Independent Scenario Analysis of the Hecla Durita Heap Leaching Site

Final Report

Prepared by
Randall Fedors, NRC Senior Hydrogeologist

Office of Nuclear Material Safety and Safeguards
U.S. Nuclear Regulatory Commission
Washington, DC 20555-0001

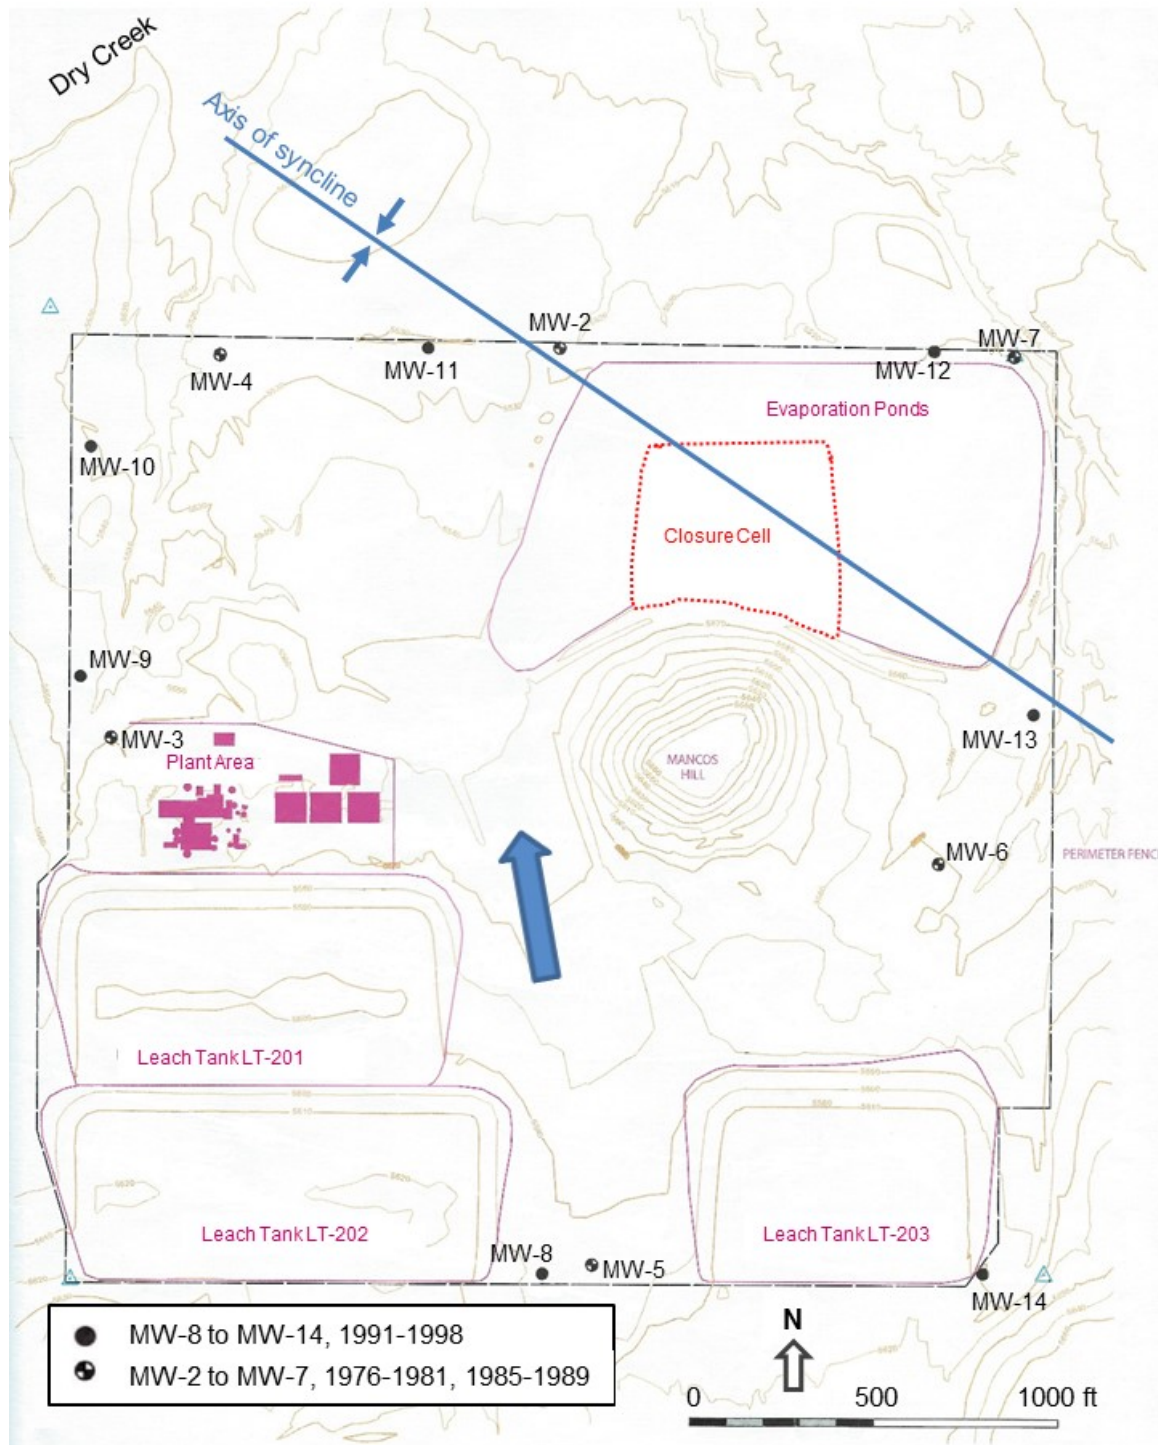
The locations of the compliance wells are not appropriate for a detection monitoring program, especially considering the expected transport times at the site and the distance from the source to the designated compliance wells. All the wells operated from 1991 to 1998 (MW-8 to MW-14) are located near site boundaries. The primary compliance well for the leach tanks, MW-11, is located approximately 500 m (1,640 ft) in the main transport path downstream from the potential source, while wells MW-9, MW-10, and MW-13 are slightly closer but would be on the lateral edge of transport pathways from the leach tanks. Considering the highest measured permeability and groundwater gradient values for the designated uppermost aquifer, a release occurring at the start of operations in 1978 would only be detected in a well that was placed within 65 m (213 ft) of the leach tank (excludes dispersion) at the time the monitoring program was stopped in 1998. Therefore, acknowledging the practical aspects of locating wells for a detection monitoring at Durita, the NRC staff has taken a practical approach and reconciles the inadequacy of the detection monitoring program through the use of conservative scenario modeling of a release in this report to reach part of its decision on whether to concur or not on the CRR.

The NRC staff assessed the CDPHE conclusions by considering additional observations and information. Perturbations of the groundwater system, such as seen in the 1993 groundwater levels (NRC, 2007) may be related to the 1993 spikes in radionuclide values. Reclamation activities were underway in 1993. Two of the wells with the highest concentrations of uranium are upgradient or cross-gradient to the leach tanks. Coincidentally these two wells, MW-13 and
